Product / Process Change Notification (PCN)	
<input checked="" type="checkbox"/> Major Change <input type="checkbox"/> Minor Change	
PCN Number: PCN_ConPSHD_20240917 Affected Series: WR-PSHD Affected Order Codes: 610114249221 PCN Date: 2024-06-17 (YYYY-MM-DD) Effective Date: 2024-09-17 (YYYY-MM-DD)	Change Category: <input type="checkbox"/> Equipment/Location <input type="checkbox"/> General Data <input type="checkbox"/> Material <input type="checkbox"/> Process <input type="checkbox"/> Product Design <input checked="" type="checkbox"/> Shipping/Packaging <input type="checkbox"/> Supplier <input type="checkbox"/> Software
Contact: Product Management Phone: +49 (0) 7942 - 945 5001 Fax: +49 (0) 7942 - 945 5179 E-Mail: pcn.eican@we-online.com	Datasheet Change: <input checked="" type="checkbox"/> Yes <input type="checkbox"/> No Attachment: <input type="checkbox"/> Yes <input checked="" type="checkbox"/> No

Packaging Specification - Tape and Reel: [mm]

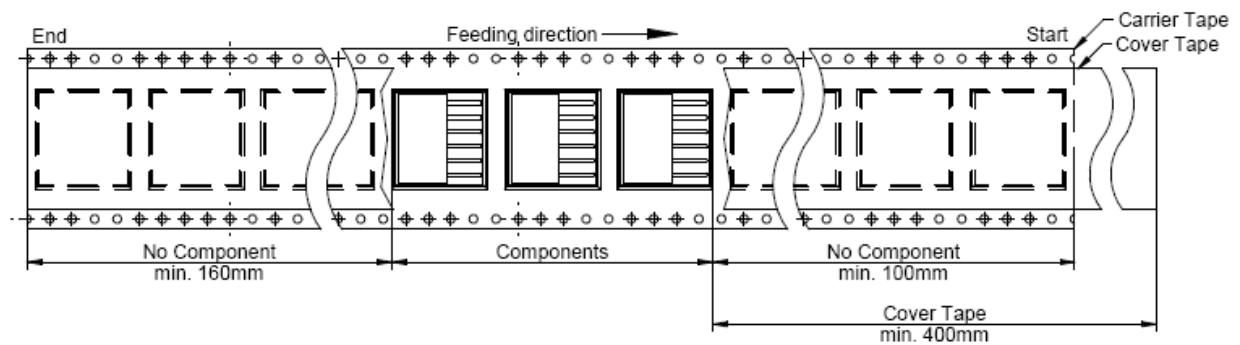
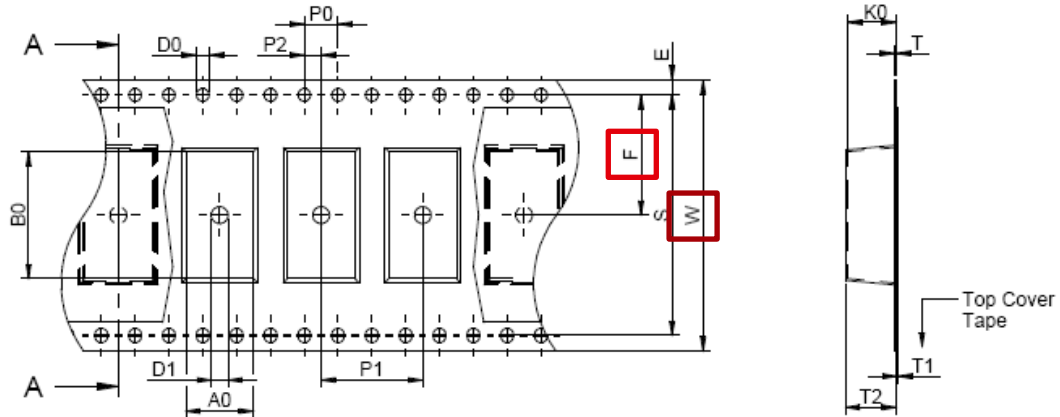
Description of Change: Due to packaging optimizations, Würth Elektronik eiSos will update tape & reel size, implying carton quantity changes. There will be no change in form, fit, function, quality or reliability of the product. The new revision of the affected order codes will be sent out after the previous revision is out of stock (according to FIFO - first-in, first-out).

Before	After
W (mm)	32	44
F (mm)	14.2	20.2
Reels / carton	7	5
Quantity / carton	3500	2500
